**ERRATA SHEET FOR
ANSI/ASHRAE STANDARD 62.1-2022
Ventilation and Acceptable Indoor Air Quality**

December 5, 2022

Figure 3-1 Ventilation system.

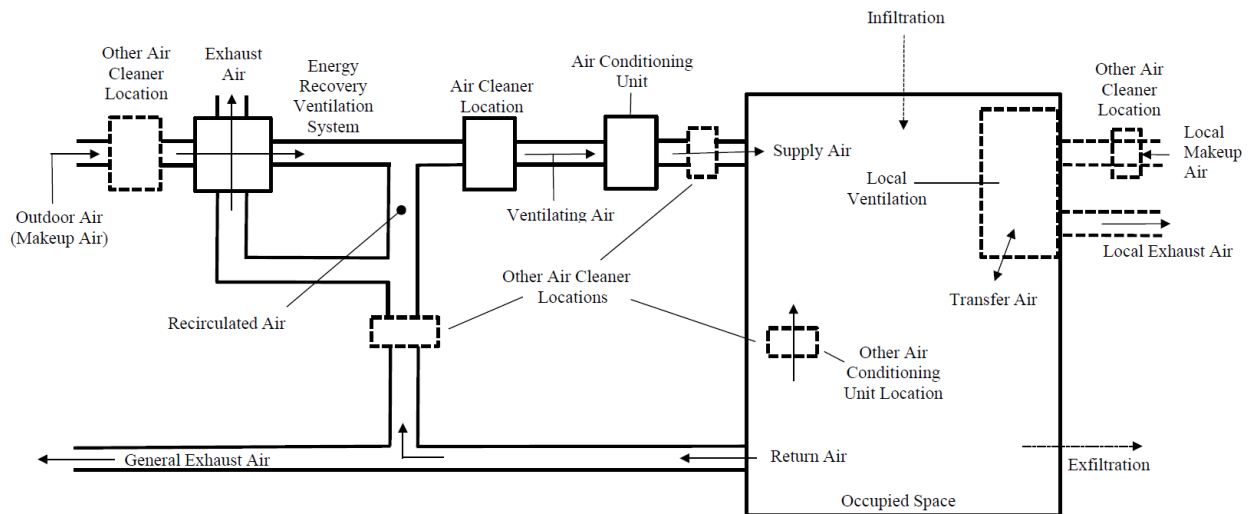
4 Figure 3-1 Ventilation system. In the Occupied Space in Figure 3-1 change “Local Ventilation” to “Local Ventilation”. Revised figure attached.
